Monterey Bay Aquarium Research Institute 7700 Sandholdt Road Moss Landing, CA 95039 (831) 775-1700 www.mbari.org		MBARI proprietary information (c) MBARI 2017	
Title Fwd Endcap, LRAUV Internal Pressure Vessel Wiring, Pontus		Document Number 100221161		Rev G	
Size Custom		Date: Thursday, March 28, 2024		Engineer Mellinger	
				Sheet 14	
				of 15	
Design File Q:\DESIGN\DRAWINGS\EE_DRAWINGS\LRAUV\WIRING\SYSTEM\RRING\00221161_LRAUV_BUILD_5_SYSTEM\RRING\DRAWING\SET.DSN					
Schematic Name LRAUVBuildInternalWiring		Page Name 14H Pontus Fwd Endcap		Layout File <Layout File>

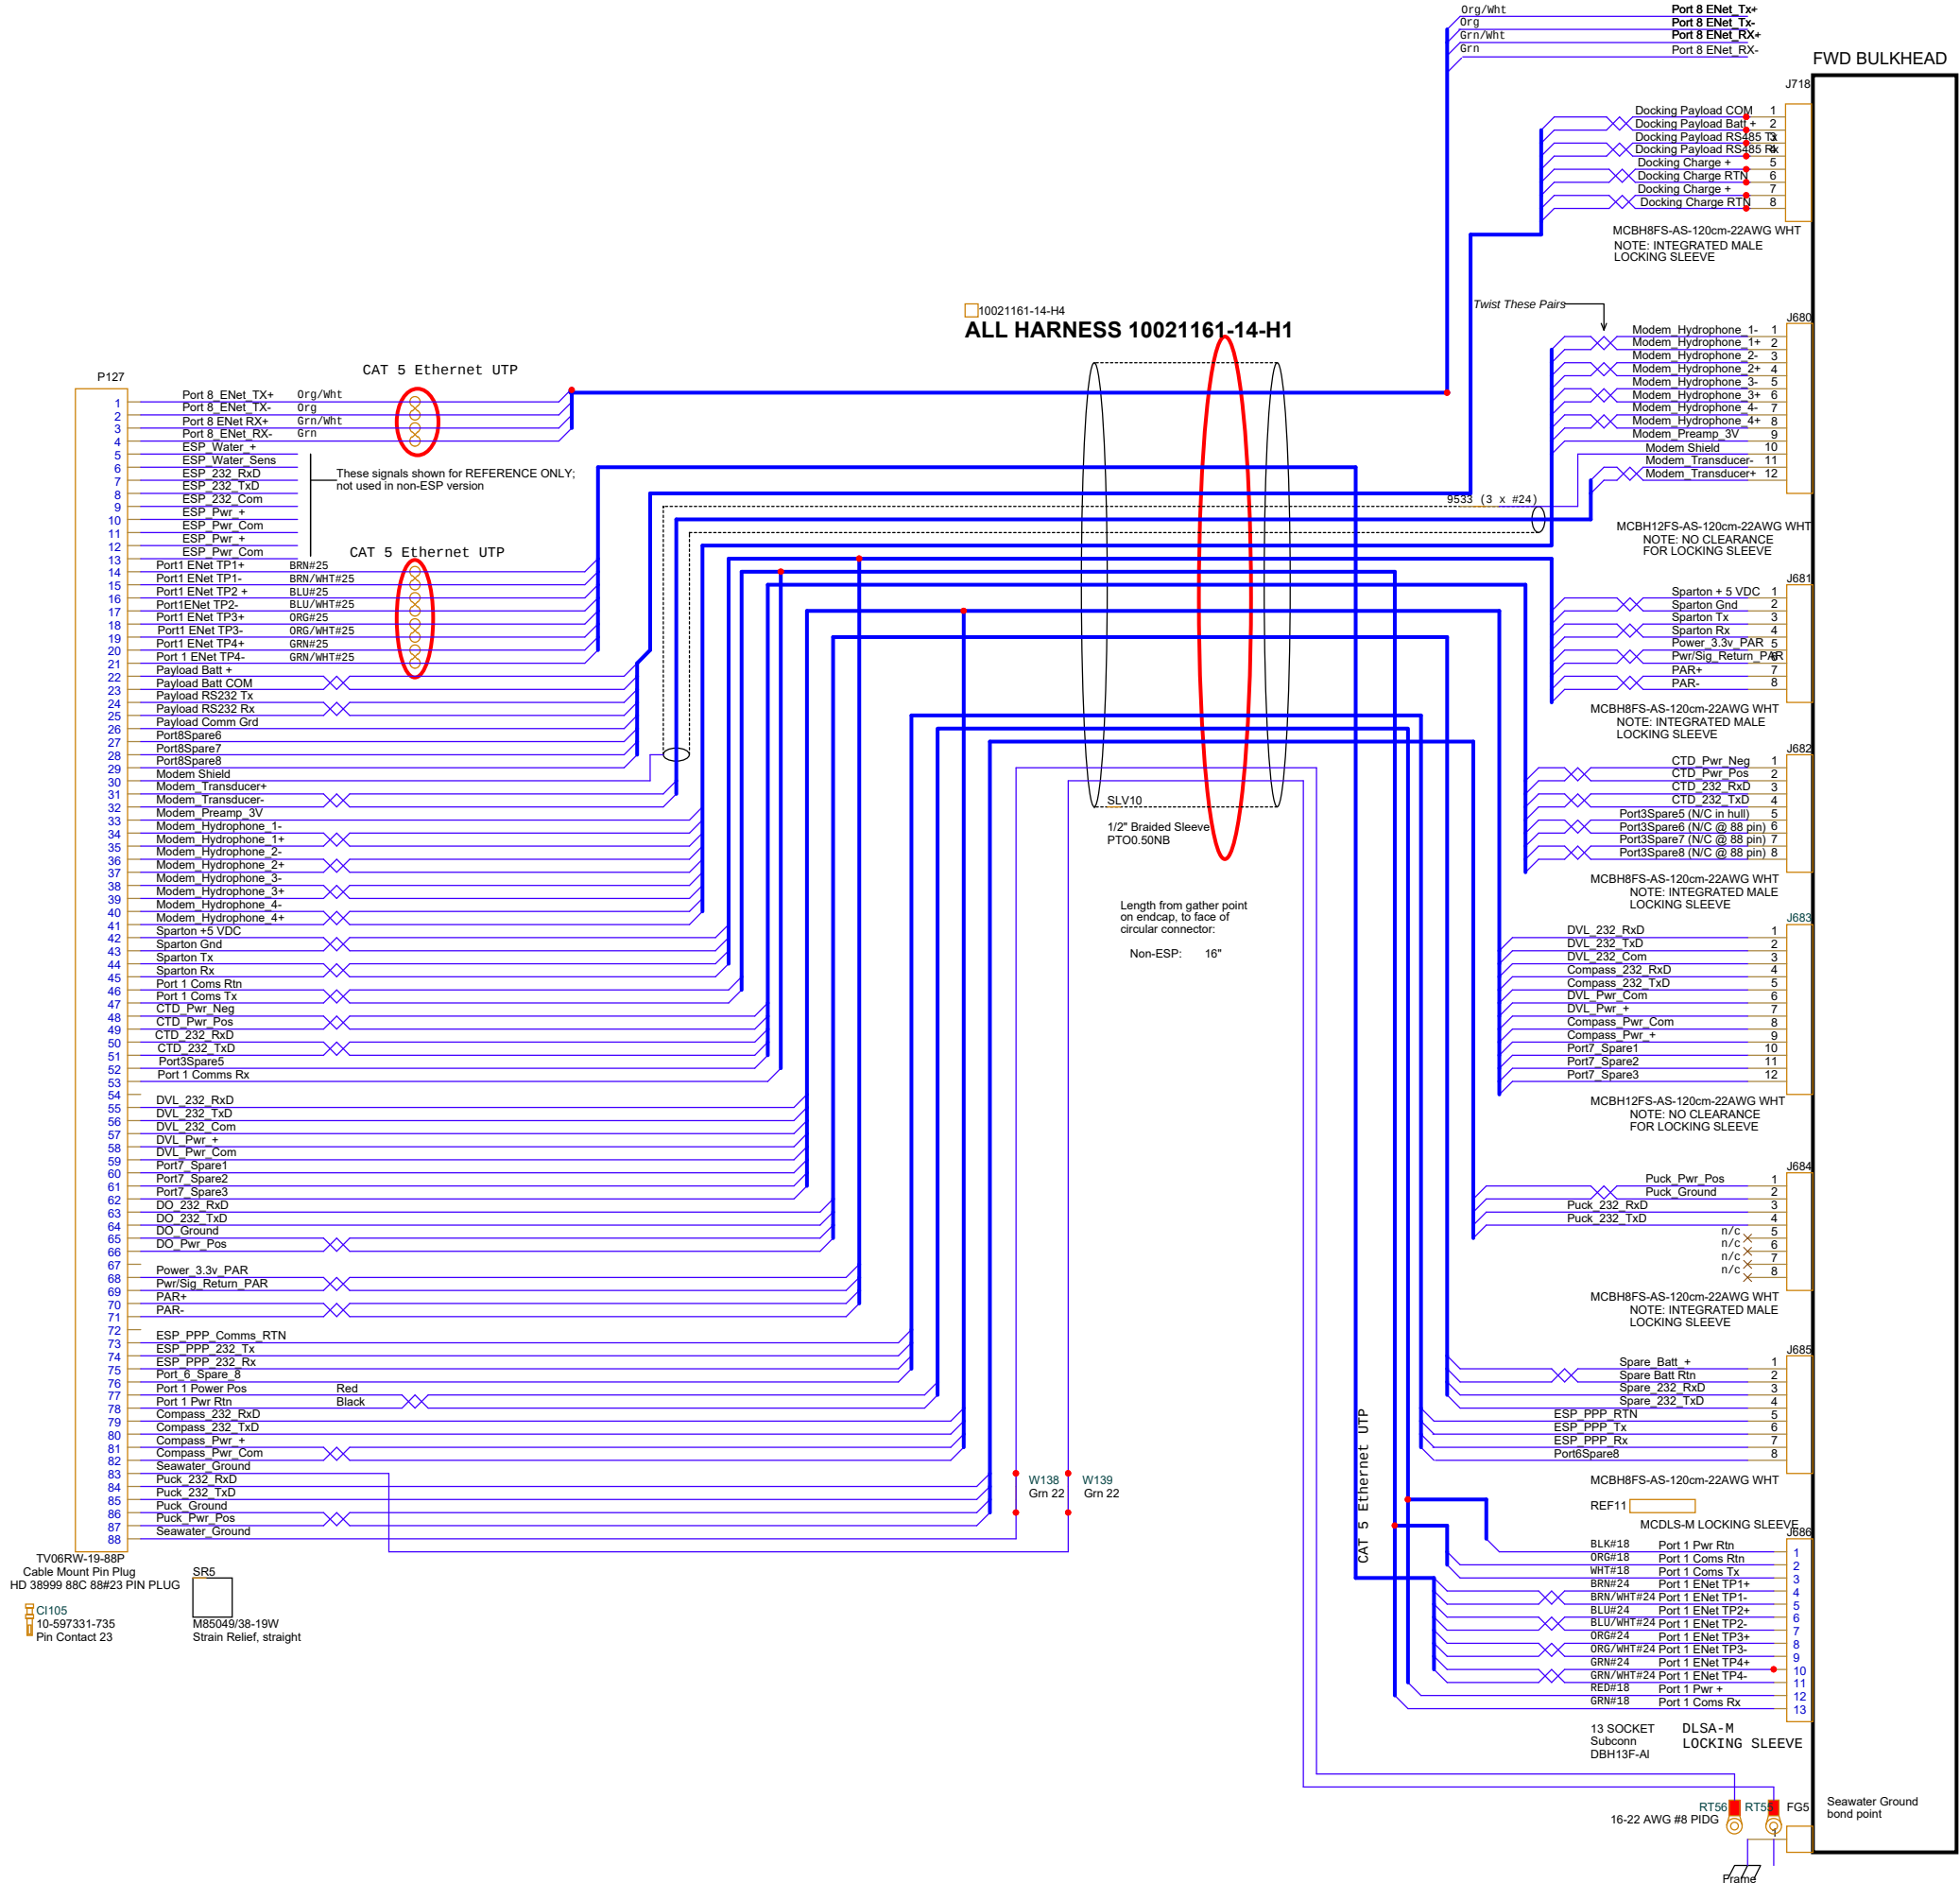
I	28 March 2024	BWH	Converted Port 8 from Ethernet+Power to Docking
H	21 April 2021	BWH	Moved Port 4 A-modem Transducer wires 31, 32 into dedicated shield, 30
G	3 Nov 2019	BWH	Moved Port 8 wires 5,6,7,8 to ESP Ethernet cable pins 1,2,3,4 on 88 Pin
F	3 Nov 2019	BWH	Converted Port 1 from NBOSI to GIGe+serial+power. Changed 8 wires to Cat6 and moved Port 6 spare 5 and 6 (75,76) for power, Port 3 spare 6,7,8 (46,47,52) for comms
E	4 Oct 2017	MRC	Corrected locking sleeve call-out on bulkhead connectors.
D	2 Jan 2017	BWH	Modified MIVEGAS for Daphne; added Port 1 for NBOSI CTD, Port 8 for Payload Bay/SIPPER
C	13 Jan 2016	ECM	Change Braided Sleeve from 0.25" to 0.5"
B	05 Jan 2016	ECM	Flip endcap layout drawing and add gather point definition, change spiral wrap to braided sleeve
A	12 Nov 2015	ECM	Fork from Dwg 10021158 Rev G 'Makai Foward Endcap Harness'. Change length to 16"
